Report: TAB REPORT
Function: Test, Adjust, & Balance
Date: 07/24/2023

06-24-24 WALGREENS #1769 - DENVER, CO

Issue List

Dirty_Filters
06/19/2024

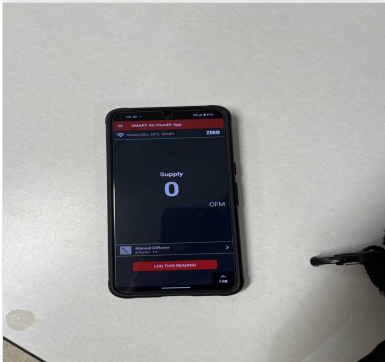
Issue Name : RTU Final Filters
Description : Recommended to install the appropriate sized MERV 8 or better throwaway filters in the RTUs for improved filtration.
Created By : National TAB **Assigned To :** National TAB - Stephen Tassinaro
Status : Open
Priority : Medium **Asset Tag :**
Originated Date : 07/20/2023 - Stephen Tassinaro - National TAB

- **06/17/2024 National TAB - Stephen Tassinaro**
 - MERV 8 filters now installed in all units, but they are dirty and due for replacement.
